Submission of Further Information (FI)

Temporary Shop and Services (Retail Shop for Hardware Groceries and Construction Materials) with Ancillary Facilities for a Period of 5 Years in “Residential (Group D)” Zone, Lots 670 (Part), 671 (Part), 673 (Part), 674, 675, 676, 677 (Part), 679 (Part) and 680(Part) in D.D. 106 and Adjoining Government Land, Yuen Long, New Territories (Application No. A/YL-KTS/1101)

Further Information for Planning Application No. A/YL-KTS/1101**Response-to-Comments****Comments from Lands Department**

Plan Showing Viewpoints of Site Photographs

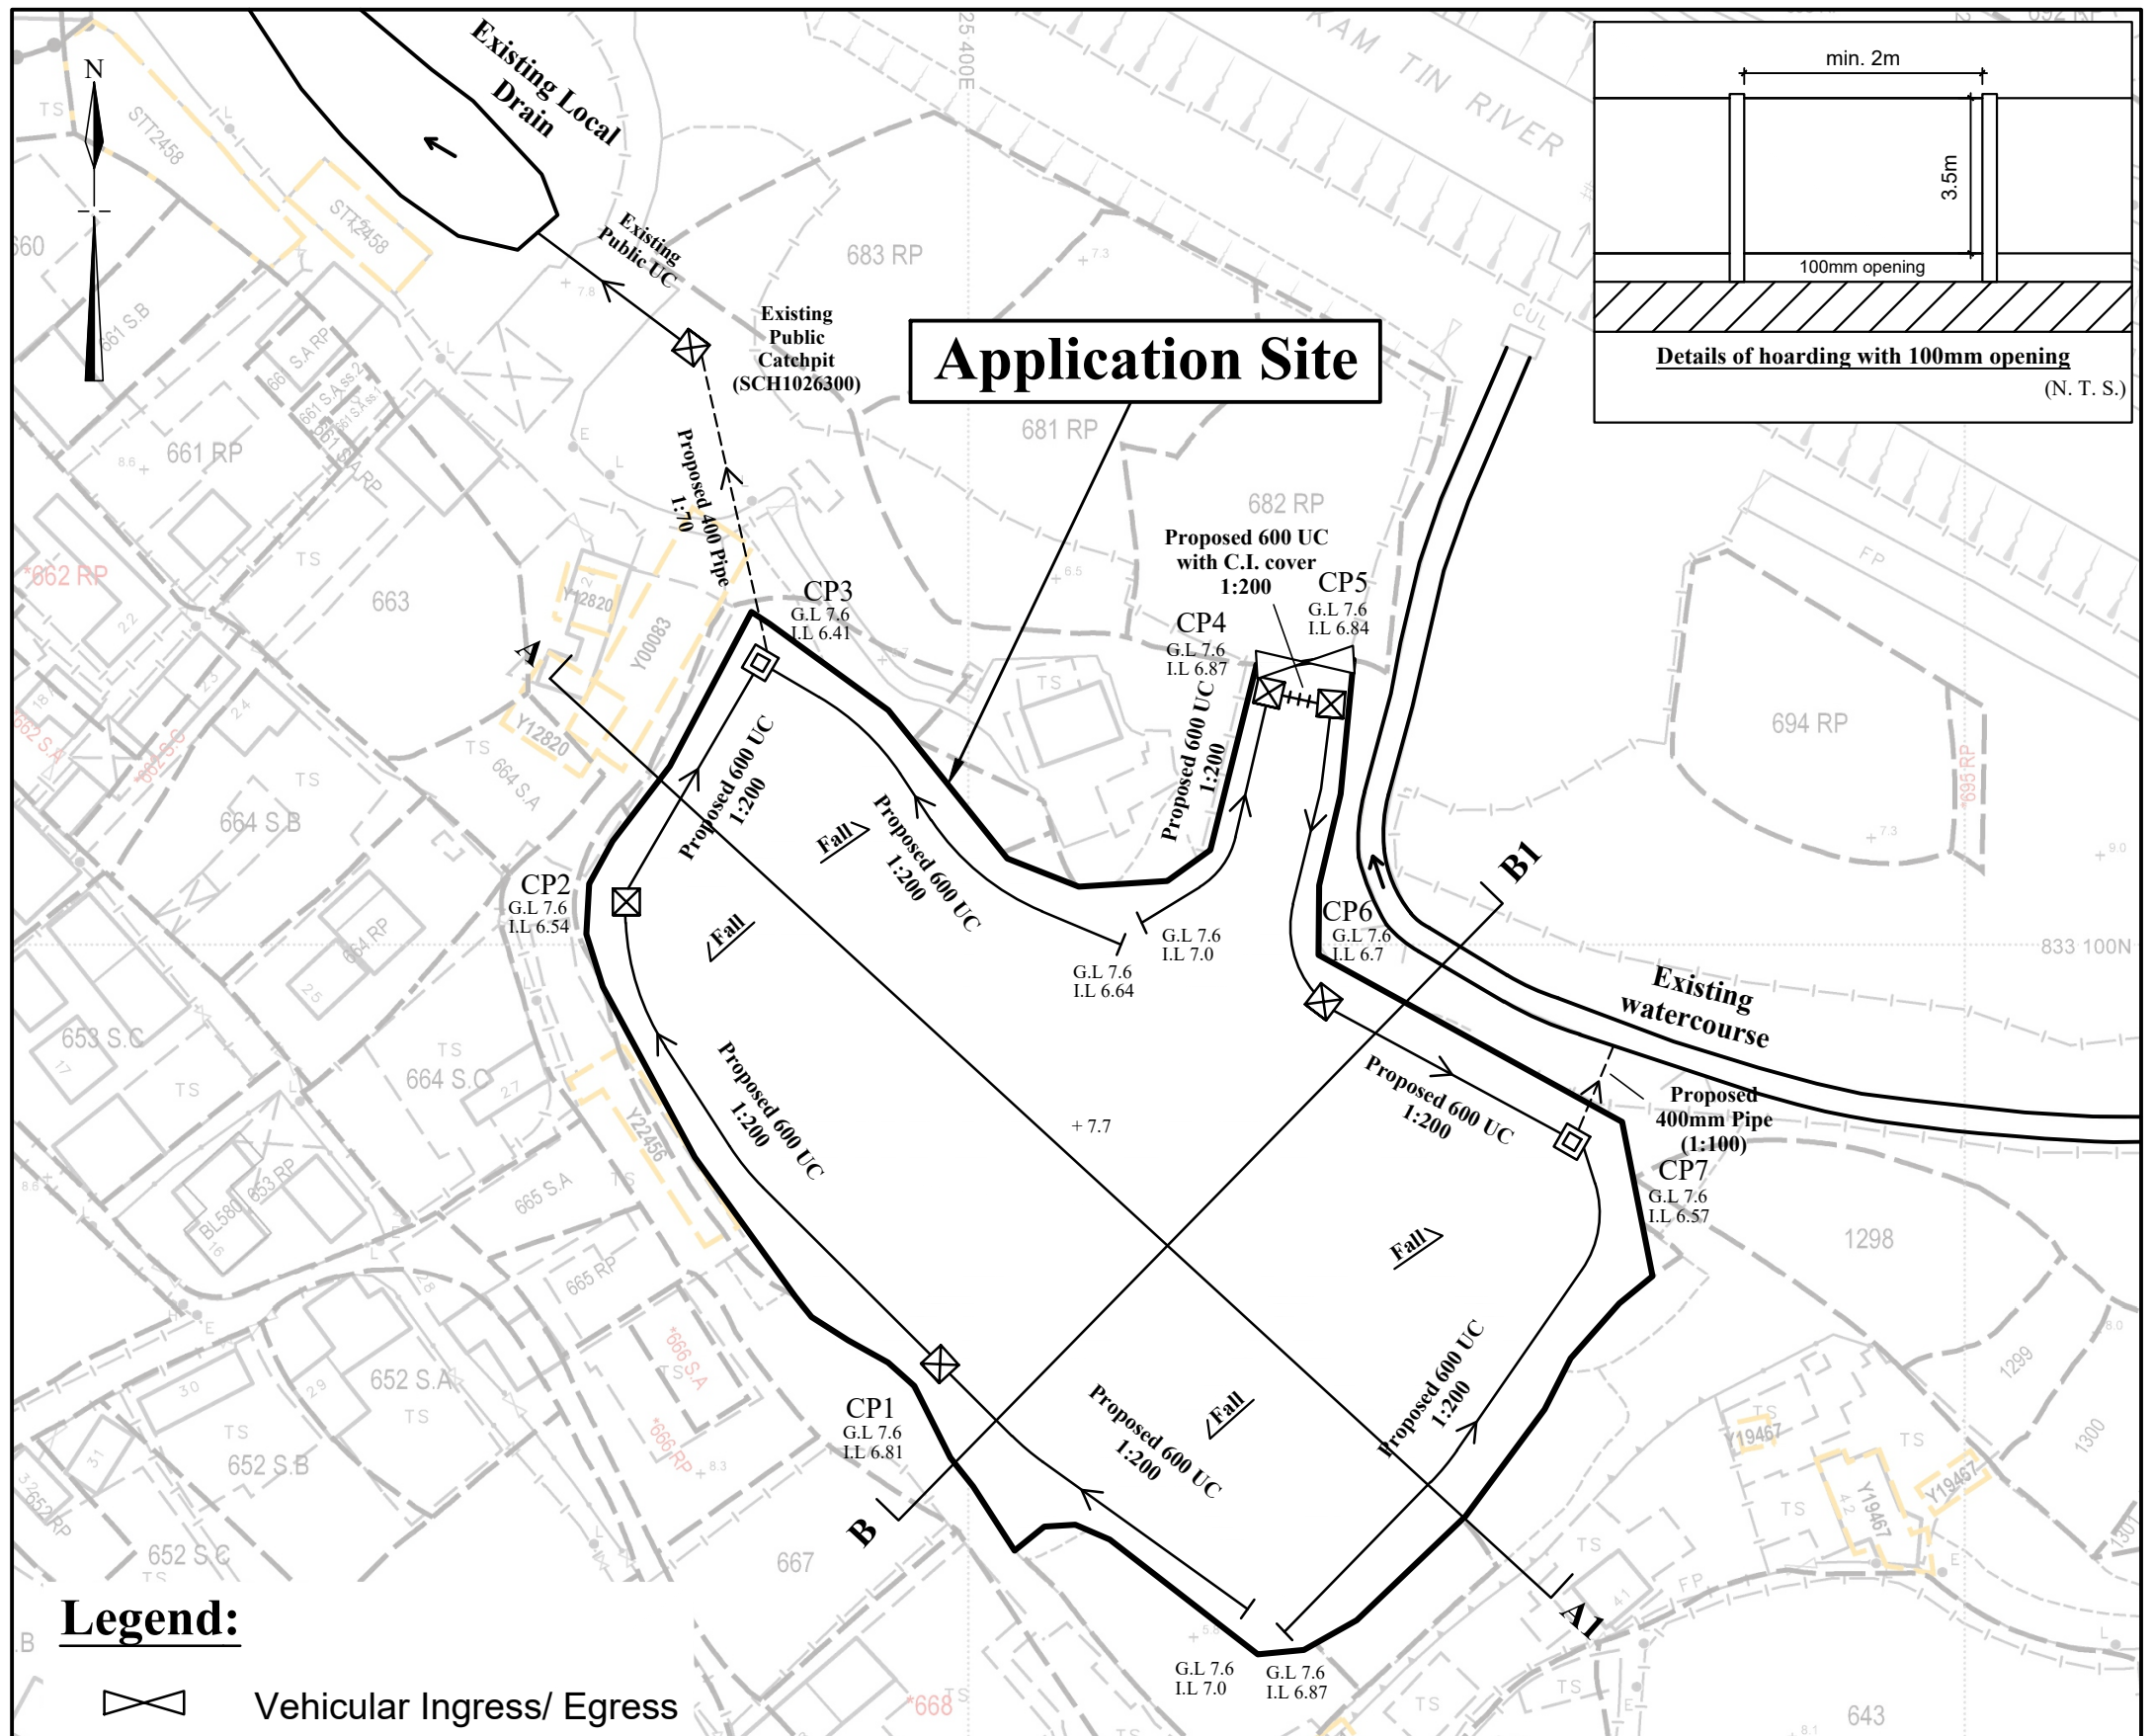
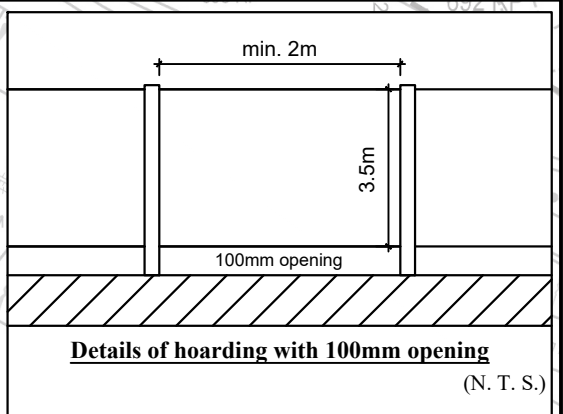
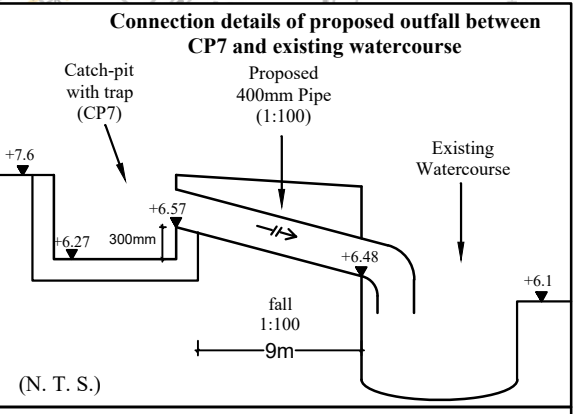
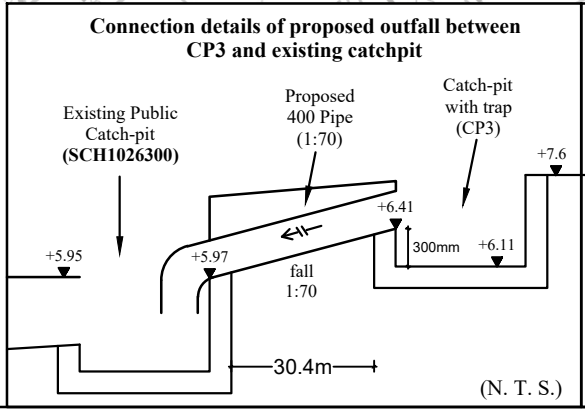
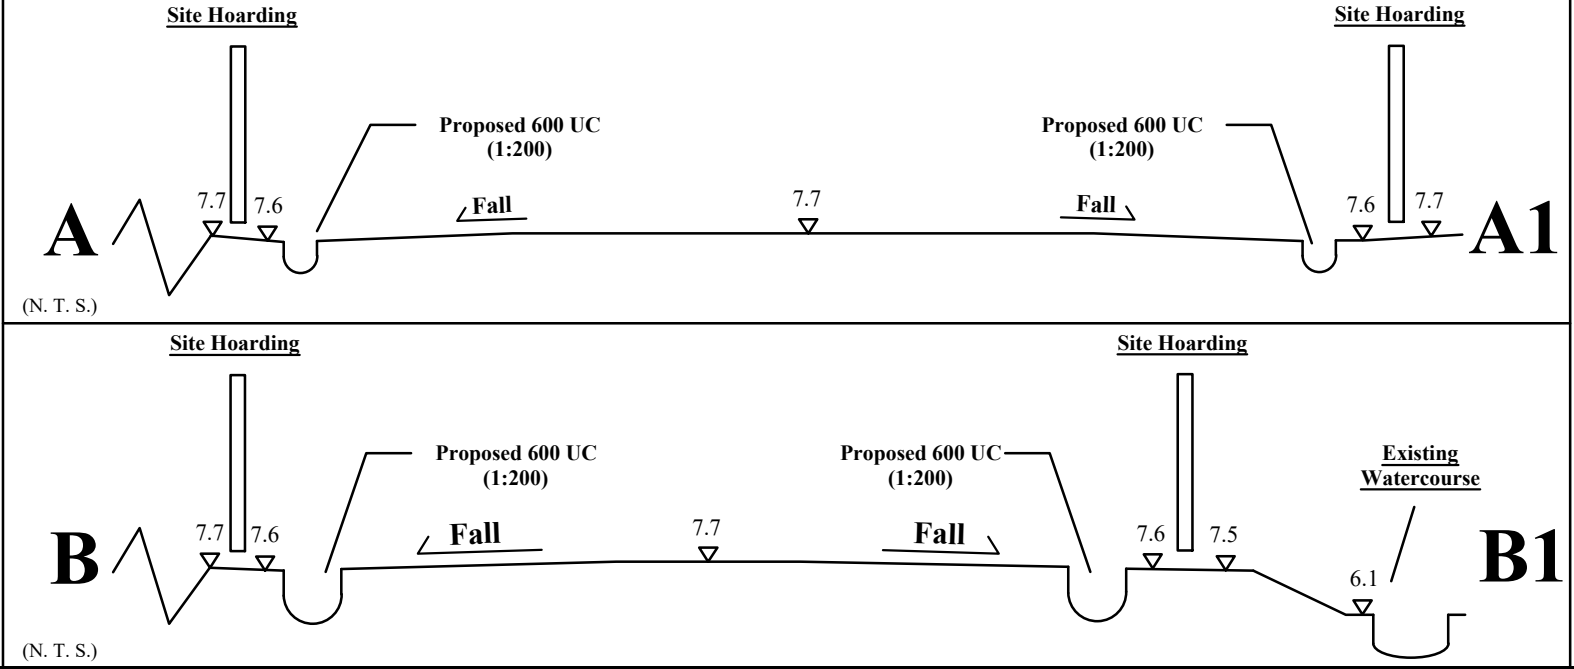
2.	<p>I must point out that the following irregularities covered by the subject planning application have been detected by this office:</p> <p><u>Unlawful occupation of Government land adjoining the said private lots covered by the planning application</u></p> <p>The Government land within the application site (about 845 m² as mentioned in the application form) has been fenced off on or after 28.3.2017 without any permission. Any occupation of GL without Government's prior approval is an offence under Cap. 28. LandsD objects to the planning application since there is unlawful occupation of Government Land (GL) and regularization would not be considered according to the prevailing land policy. The lot owner(s) should immediately cease the unlawful occupation of GL as demanded by LandsD. This office reserves the rights to take necessary land control action against the unlawful occupation of Government land without further notice.</p> <p>The lot owner(s)/applicant shall cease the unlawful occupation of Government land and, subject to the approval of the Town Planning Board to the planning application which shall have reflected the rectification as aforesaid required, apply to this office for an STW and/or STT to permit the structure(s) erected and the occupation of the Government land. The application(s) for STW and/or STT will be considered by the Government in its capacity as a landlord and there is no guarantee that they will be approved. The STW and/or STT, if approved, will be subject to such terms and</p>	<p>The fencing within the Government land has been removed. Please refer to the Plan Showing Viewpoints of Site Photographs (Plan 6) and the site photos (Viewpoints 1-4) for details.</p>

Plan 5.1a
(P 22068A)

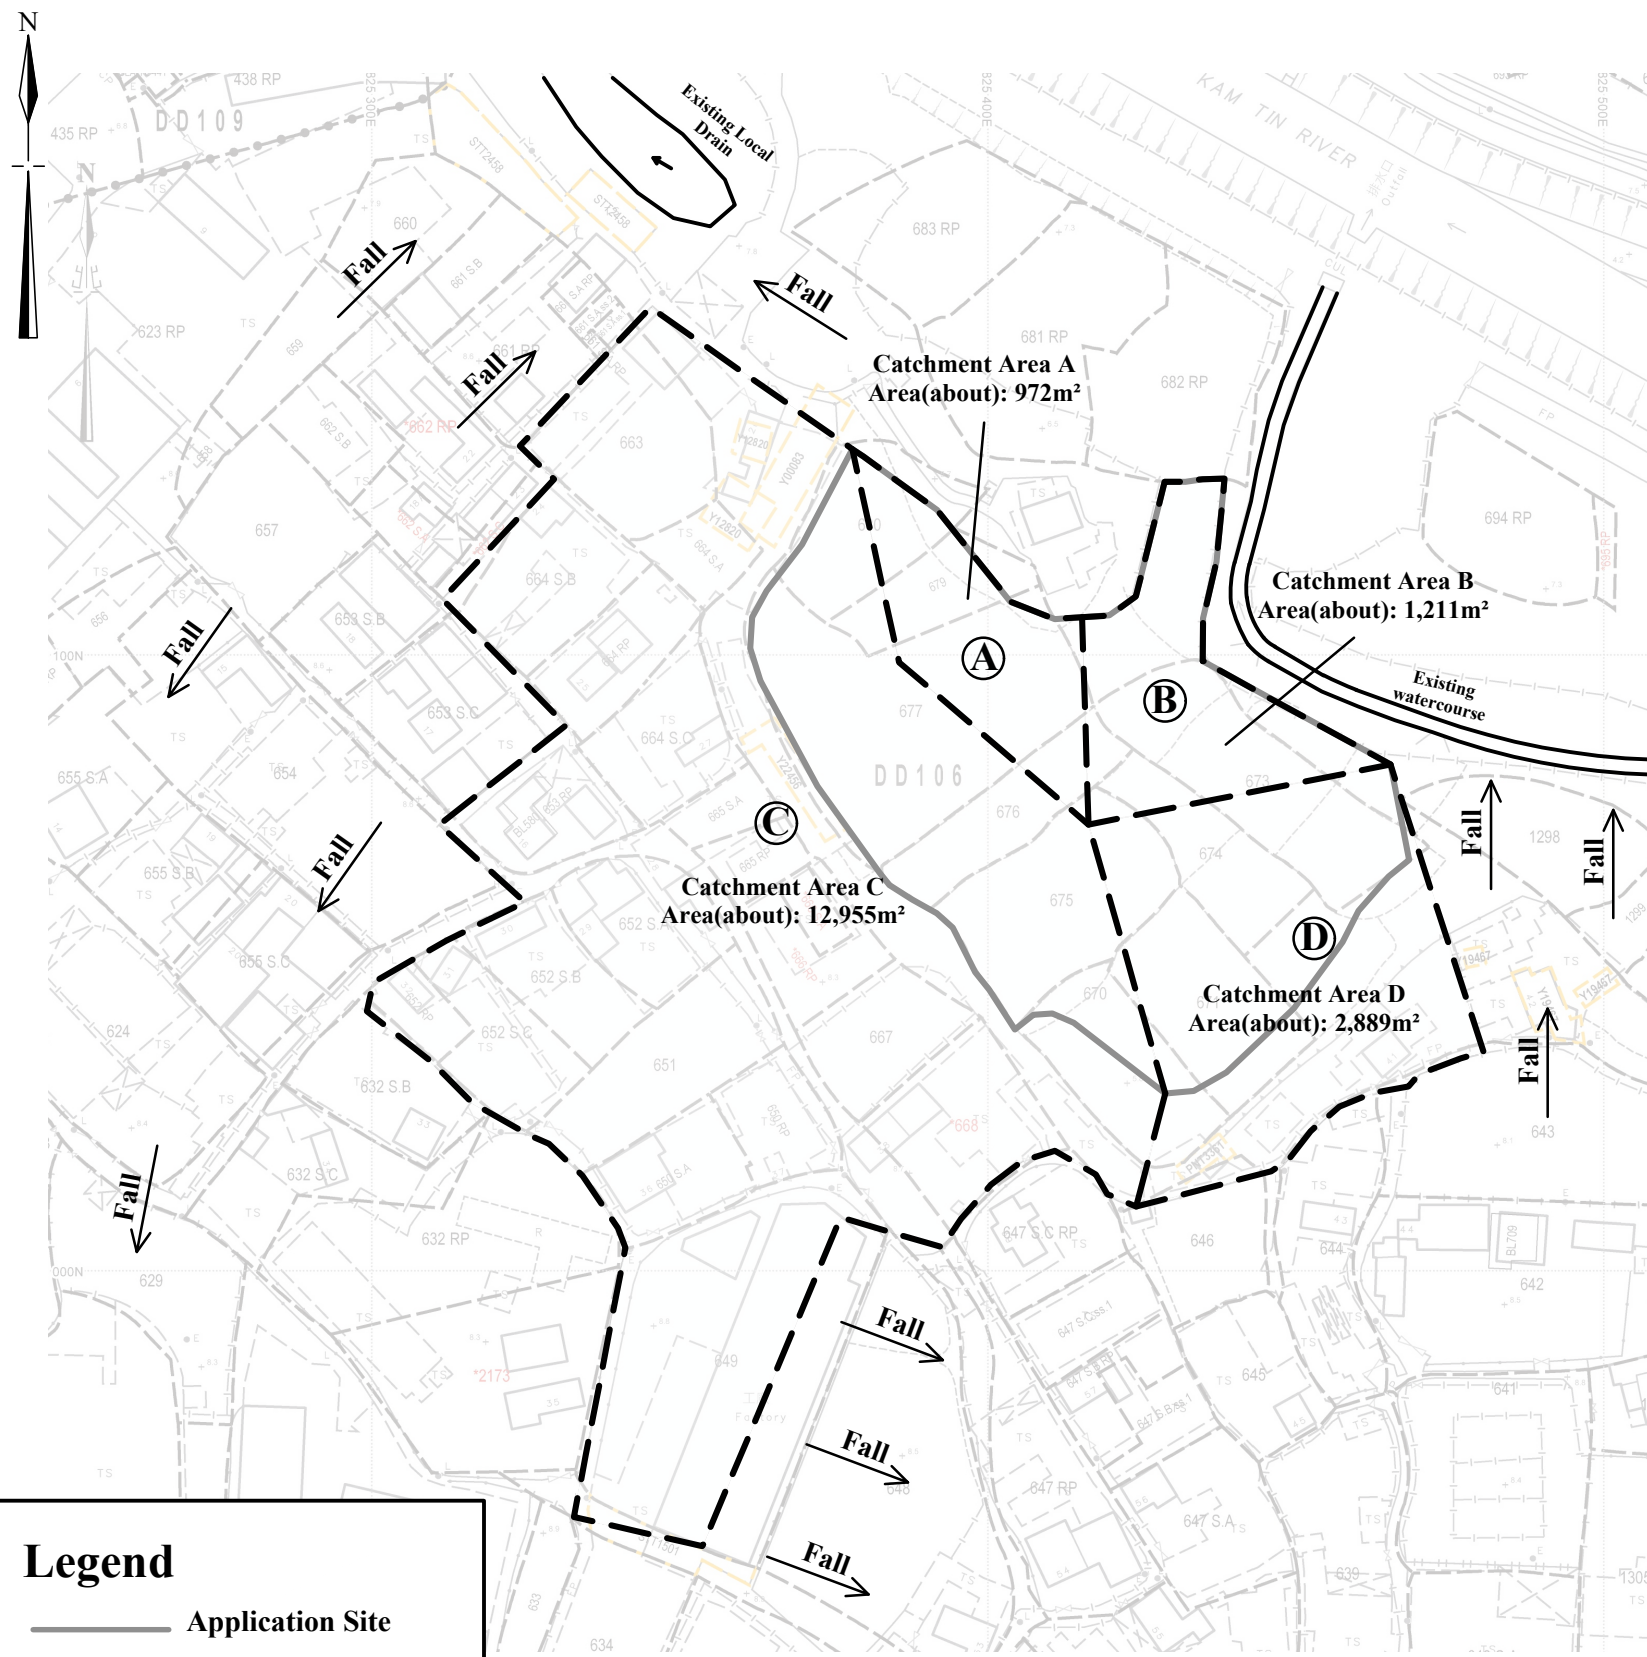
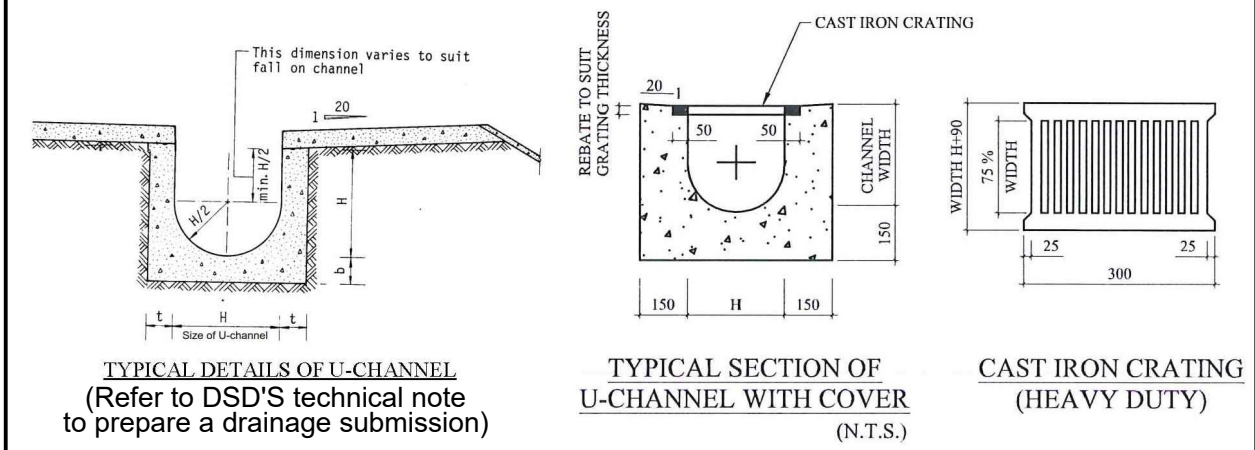
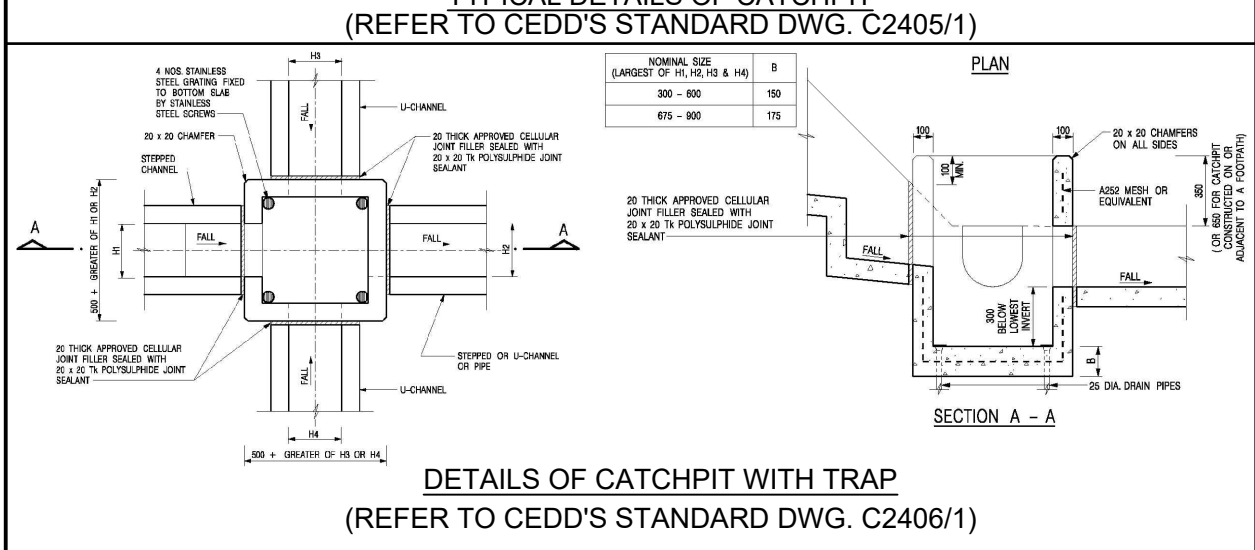
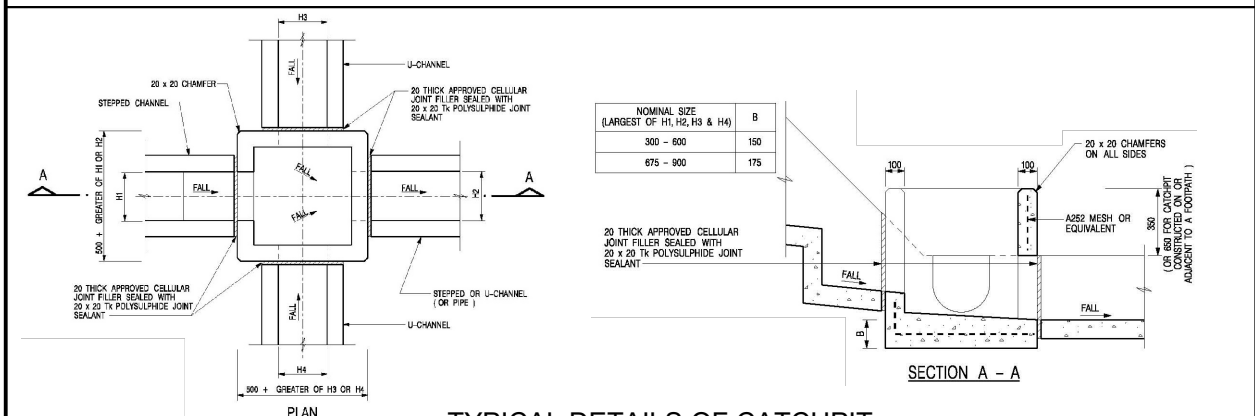
2.	<p>It is noted that the proposed 400mm pipes connecting from a) CP3 to the existing public catchpit and b) CP7 to the existing public watercourse are quite steep with a gradient of 1:25 and 1:8 respectively. Please review the gradient of the proposed drainage system and check the velocity of the flow for these proposed drainage facilities for further comments. According to the connection details provided in Plan 5.1, it is noted that the invert level of the proposed 400mm pipe to the existing public watercourse will be +5.75mPD.</p>	<p>The gradient and the invert level of the drainage facilities are reviewed. Please refer to Plan 5.1a.</p>

In this regard, the top level of the above mentioned 400mm pipe will be higher than the existing river bank (> +6.1mPD), which is not desirable from public drainage point of view. Please review.

4.	The details of the opening (100mm opening) for the proposed hoarding should be indicated on the drainage plan (Plan 5.1) for clarity.	Noted. Please refer to Plan 5.1a.
